FF-L-2937
AMENDMENT 2
February 1, 2007
SUPERSEDING
AMENDMENT-1
May 22, 2006

FEDERAL SPECIFICATION

COMBINATION LOCK, MECHANICAL

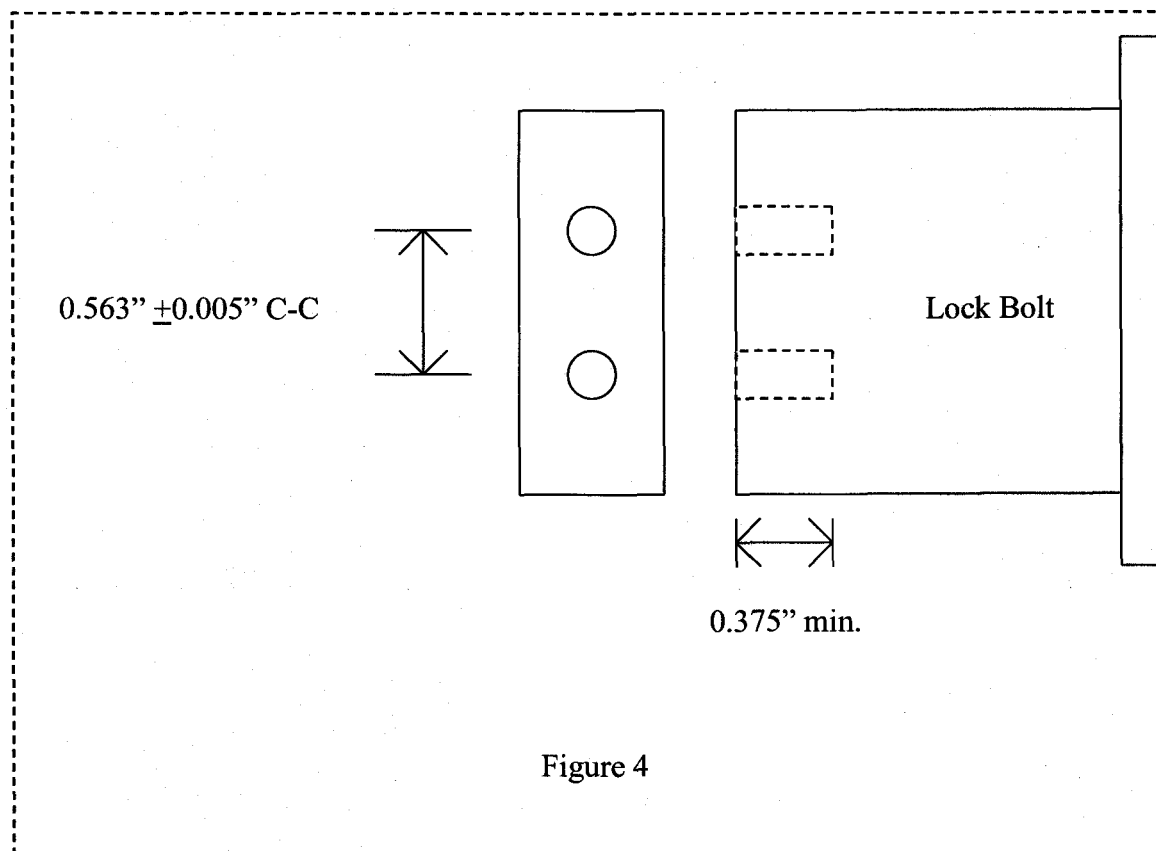
3.13.2 Bolt Design. The locking bolt shall have two threaded holes in the end of the bolt. The holes shall be #10-32 UNF with a center to center distance of 0.563 ± 0.005 inch. The holes shall be tapped to a minimum depth of 0.375 inch (see figure 4).

Add the following Figure to the end of the document:
